## SONARtrac® Technical Bulletin

Subject: 4-20 mA Output Change

TB001
Priority: 4
Date: 27-Feb-04
Rev: 01

4 - 20 mA Output vs Flow Velocity

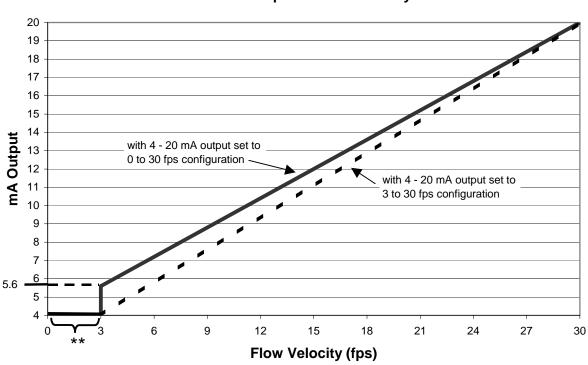
Software Version 01.05.10 and above changes scaling of the 4 - 20 mA output from 3 - 30 ft per sec to 0 - 30 ft per sec.

This change is represented graphically as follows:

At the system Low Flow Cut Off of 3.0 fps, the value from the 4 - 20 mA output will be 5.6 mA.

<sup>\*\*</sup>At flows less than 3.0 fps, greater than 30.0 fps, or if the meter is not working, the display will read as configured in the setup of the output (i.e. 'Hold' (at last value), <4 mA, 4 mA or >20 mA).
